# LORSON RANCH

## A PLANNED UNIT DEVELOPMENT FOR CARRIAGE MEADOWS SOUTH AT LORSON RANCH FILING 2

CARRIAGE MEADOWS SOUTH AT LORSON RANCH FILING NO. 2
El Paso County, Colorado
PUD & PRELIMINARY PLAN

COVER SHEET

SITE PLAN

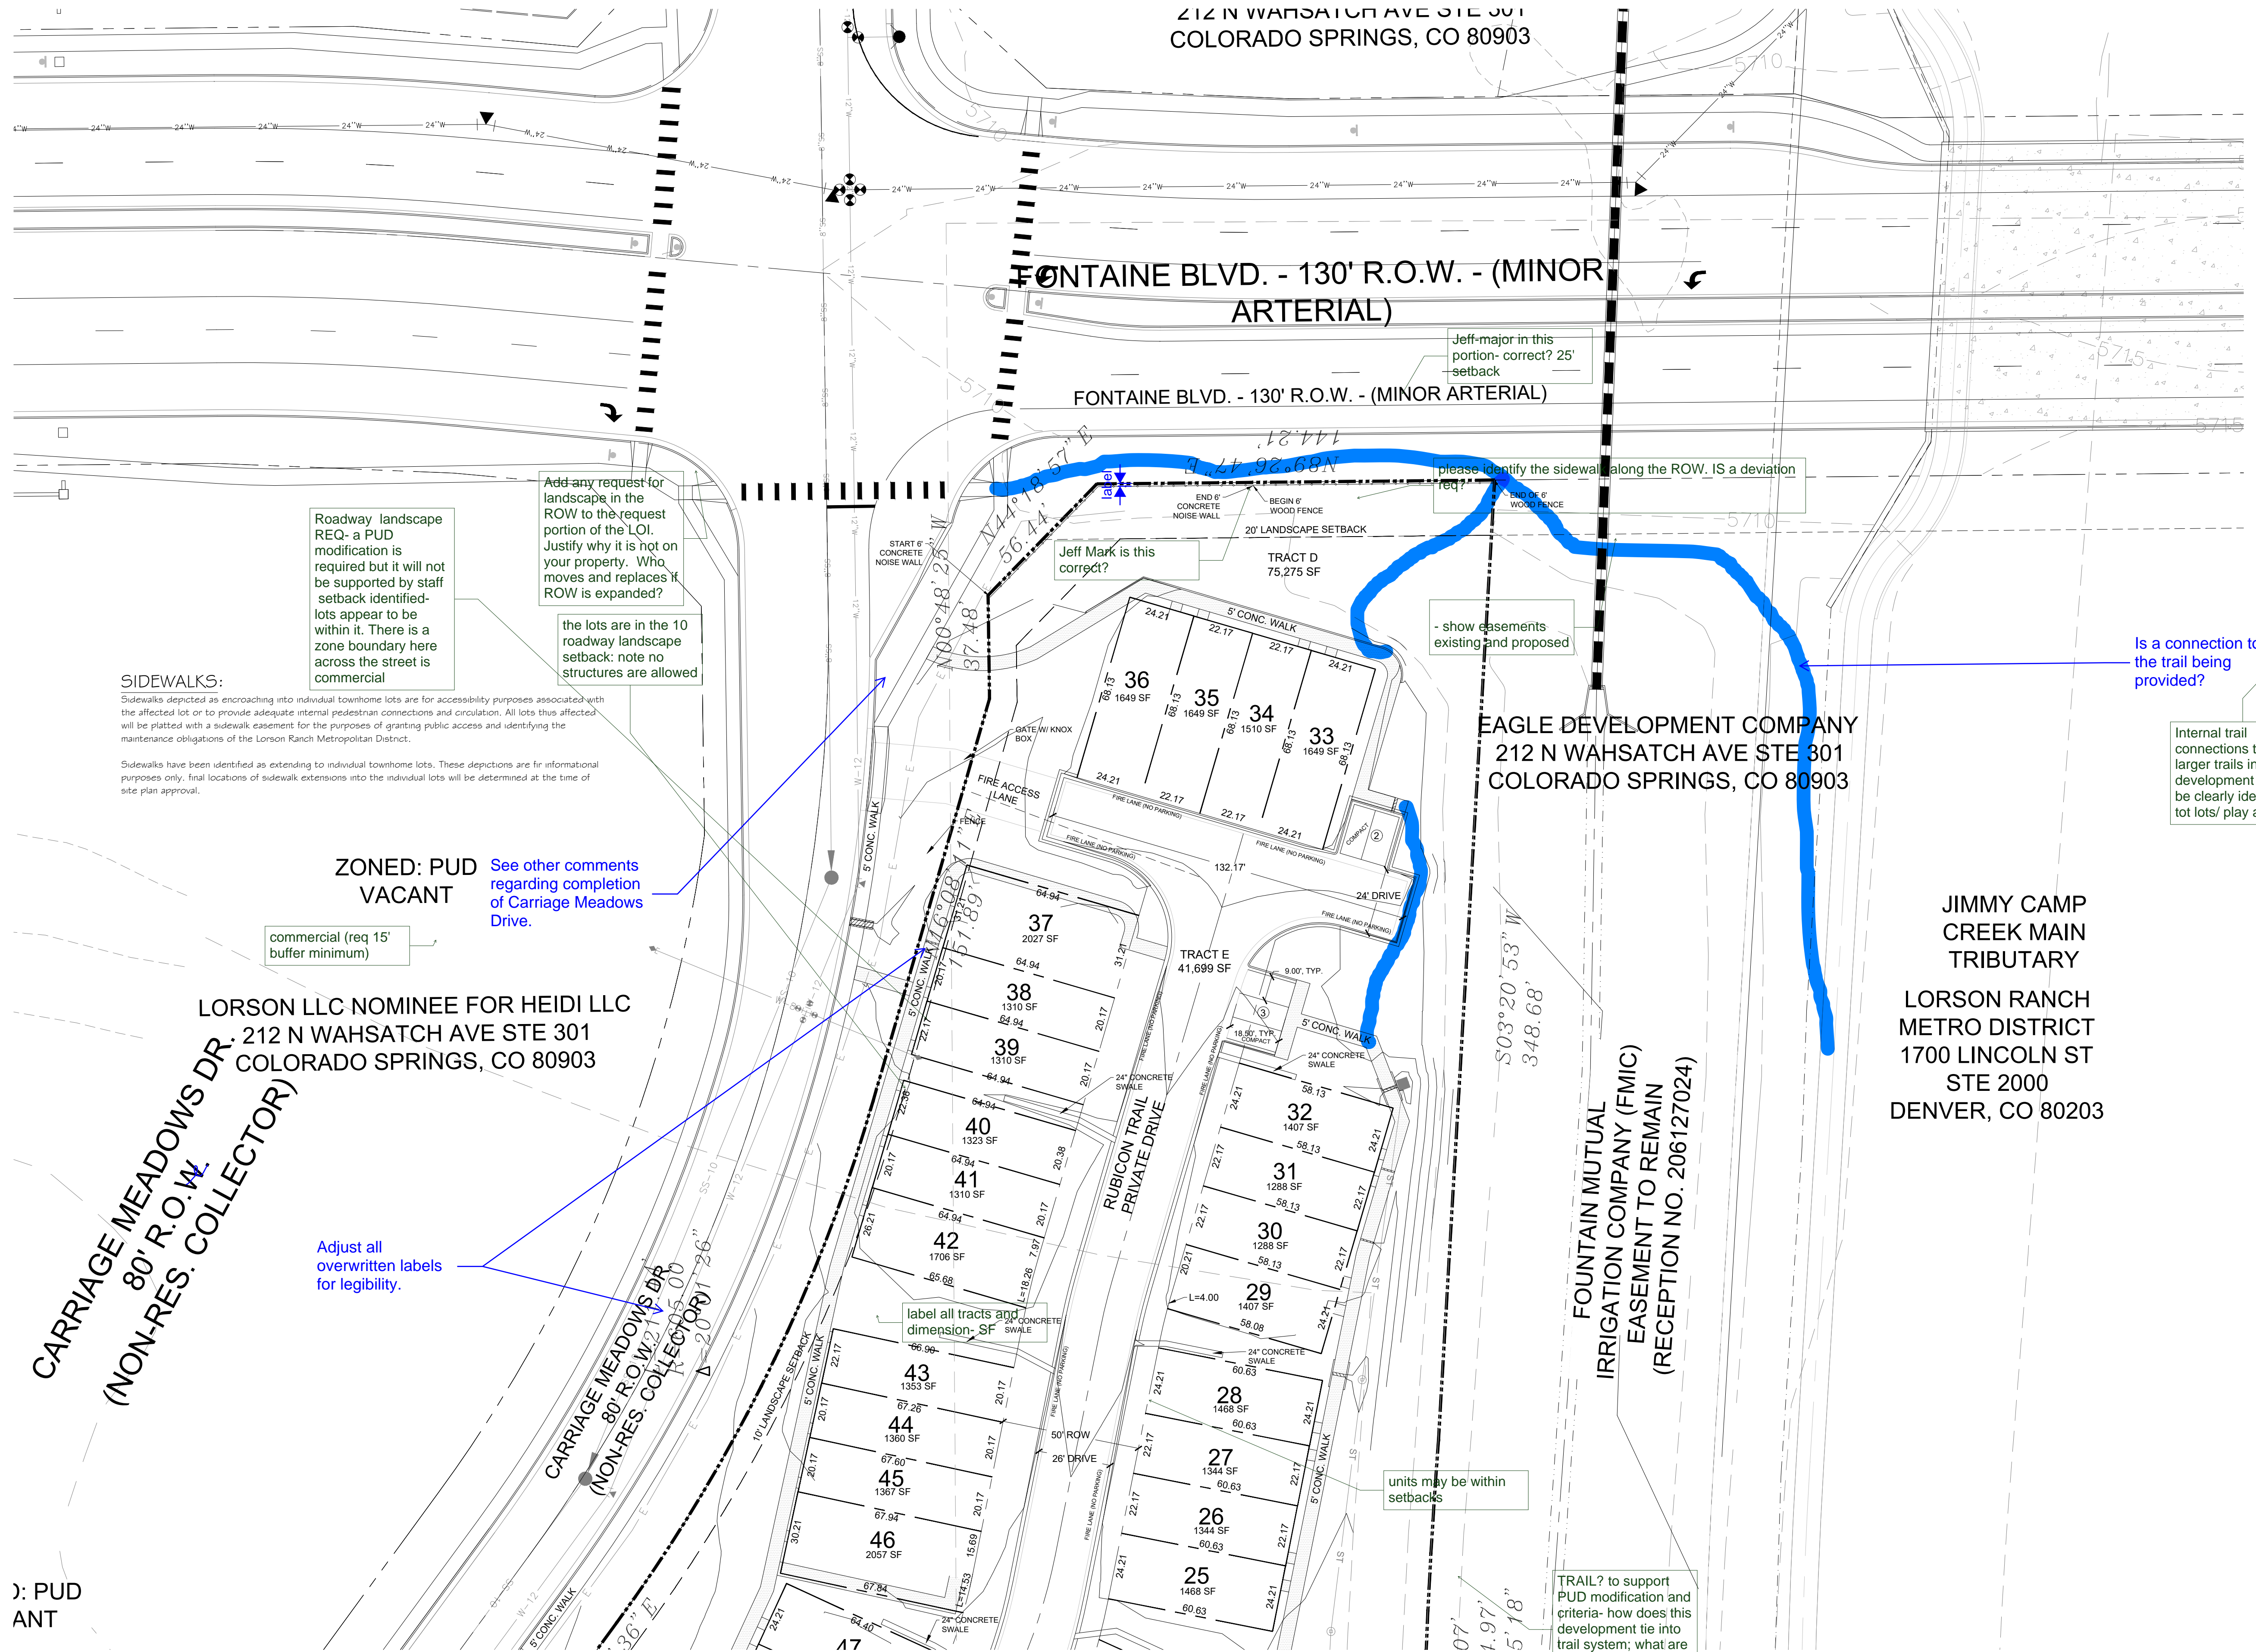
Roadway landscape REQ- a PUD modification is required but it will not be supported by staff setback identified-lots appear to be within it. There is a zone boundary here across the street is commercial

Add any request for landscape in the ROW to the request portion of the LOI. Justify why it is not on your property. Who moves and replaces if ROW is expanded?  
the lots are in the 10 roadway landscape setback: note no structures are allowed

ZONED: PUD VACANT  
See other comments regarding completion of Carriage Meadows Drive.

commercial (req 15' buffer minimum)

Adjust all overwritten labels for legibility.

label all tracts and dimension- SF

units may be within setbacks

TRAIL? to support PUD modification and criteria- how does this development tie into trail system; what are the amenities as required per criteria?
